Access Compliance Report Public Rights-of-Way (Curb Ramps)

Main Street: DORRANCE_DR		Cross Street: N/A		Location:	NW
ADA ID: RPRK220223150827	Ramp Type: Type 4 - Parallel	Initial Pass/Fail: Fail	Overall Compliance: No	Severity Score:	15
Codes/Mitigation Info/Possible Solution			Field Measurements/Component Compliance

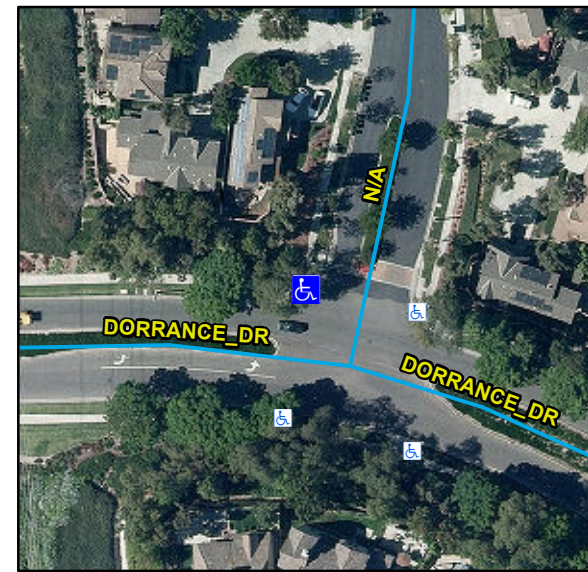
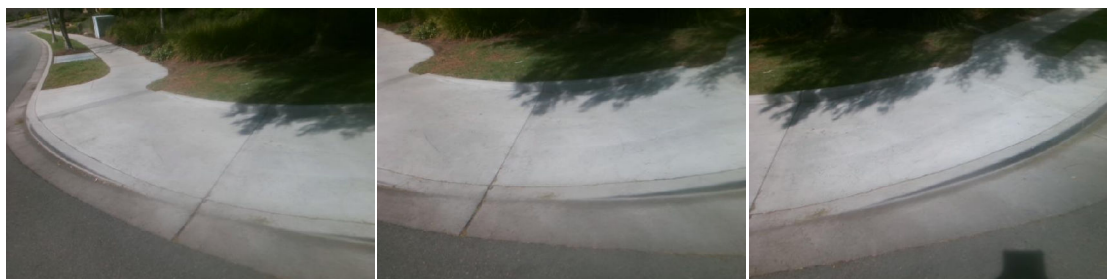
Compliance	Description	Data	Compliance	Description	Data
N/A	Ramp Length LT (in)	132	N/A	Ramp Length RT (in)	132
Yes	Ramp Width LT (in)	90	Yes	Ramp Width RT (in)	90
Yes	Ramp Run Slope LT (%)	1.5	No	Ramp Run Slope RT (%)	9.4
Yes	Ramp Cross Slope LT (%)	1.7	Yes	Ramp Cross Slope RT (%)	1.6
N/A	Landing Present	N/A	N/A	DWS Provided	N/A
N/A	Landing Length (in)	N/A	N/A	DWS Contrast	N/A
N/A	Landing Width (in)	N/A	N/A	DWS Length (in)	N/A
N/A	Landing Run Slope (%)	N/A	N/A	DWS Full Width	N/A
N/A	Landing Cross Slope (%)	N/A		DWS Offset Type	N/A
N/A	Landing Movement Obstructed?	N/A	N/A	DWS Offset Left (in)	N/A
	Landing Movement Type	N/A	N/A	DWS Offset Right (in)	N/A
N/A	Landing Shared	N/A			
N/A	Clear Space	Yes			
N/A	Clear Space To Crosswalk (in)	48			
N/A	Marked Crosswalk 1	No	N/A	Marked Crosswalk 2	No
	Crossing 1 Direction	S		Crossing 2 Direction	N
N/A	Marked Crosswalk 1 Width (in)	N/A		Marked Crosswalk 2 Width (in)	N/A

Remove & Replace Curb Ramp With Two New Directional Ramps or Equivalent.

R304.3.2, STD 1115
